UNITED STATES PATENT AND TRADEMARK OFFICE

APPLICATION NO.	FILING DATE	FIRST NAMED INVENTOR	ATTORNEY DOCKET NO.	CONFIRMATION NO.
10/591,627	09/05/2006	Franz Schwendemann	15407.0001USWO	3314
23552 7590 04/30/2009 MERCHANT & GOULD PC P.O. BOX 2903 MINNEAPOLIS, MN 55402-0903				
EXAMINER YABUT, DANIEL D				
ART UNIT		PAPER NUMBER		
3656				
MAIL DATE		DELIVERY MODE		
04/30/2009		PAPER

Office Action Summary

DETAILED ACTION

Figure Y: View of supporting member within rotor drive in the device of Frey et al.

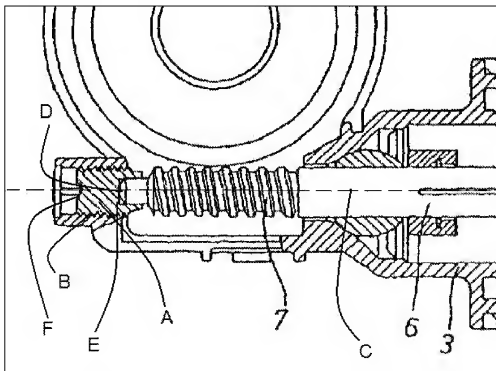
- Rotor (6) positioned with bearings (see bearings near 6 and 14 in Fig. 1) in a housing (Fig. 1)
- Rotor being supported with at least one front face (18) axially on a supporting member (34), which is attached via a form closure on the housing
- Supporting member (A; see Figure Y below) having radial crosspieces (see paragraph [0029], lines 8-10) that can be turned into the housing (3) thereby creating chamfers. **Note:** *Frey discloses the supporting member as a set screw with an external thread, see paragraph [0029], lines 8-10, which is commonly known in the art to be capable of turning into a housing and creating chamfers as described in the specification.*

- Supporting member having a cylindrically shaped base plate (at A; see Figure Y below) having its own cylinder axis (C; see Figure Y below) wherein the base plate has an outer circumference where crosspieces (B; see Figure Y below) are arranged in a plane approximately perpendicular to the cylinder axis (see crosspieces in planes approximately vertical to the cylinder axis C in Figure Y below)

- Crosspieces (B) are arranged in several planes, which are axially spaced in intervals (see Figure Y below)

- Front face of the rotor has a radius (D; see Fig. Y below) that rests against a flat stop surface (E; see Fig. Y below) that is formed on the supporting member

- Advancement of the supporting member (see paragraph [0029] lines 8-14) as well as a notch-like feature (F; see Figure Y below) formed on the support member which is deemed to be a form closed entrainment member.

Frey et al. discloses all of the claim limitations, see above, including an attachment area for the supporting member (at B in Figure Y above) but does not disclose the following, respectively:
